Sangaku DIY – R2 error

The Sangaku DIY PCB has an error that results in a DC offset to appear on the unbalanced outputs and the preamp outputs. It is not an issue for balanced headphones as the offsets will cancel.

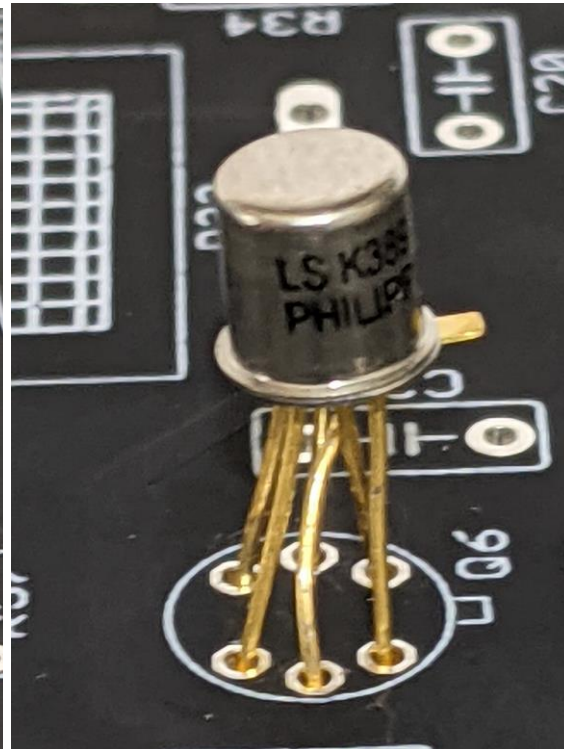
The mistake is that the signal was taken from the wrong side of the 100 ohm resistor on the JFET buffers between the nutube plates and the opamp output stages. To correctly cancel the DC offset, the signal should come off of the drain terminal of the lower (CCS) FETs Q6 and Q7.

1. Swap the two leads on the JFETs Q6 and Q7, like this:

You need to keep the leads from shorting. You may want to put some insulation (like the insulation stripped from a piece of hookup wire) on one or two leads.

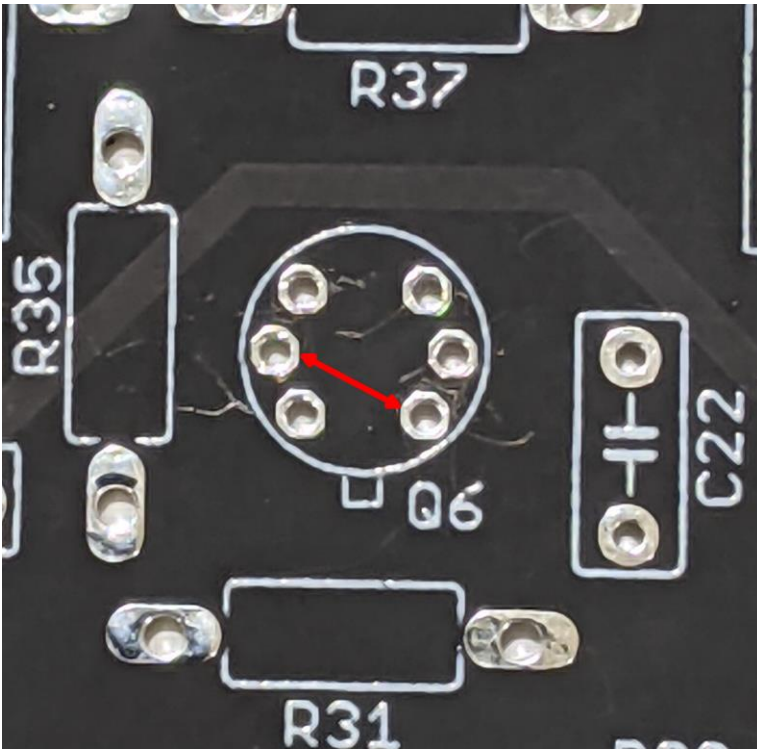
2. Cut the traces on the back side of the PCB as shown below, and add a wire as shown, to move the signal.
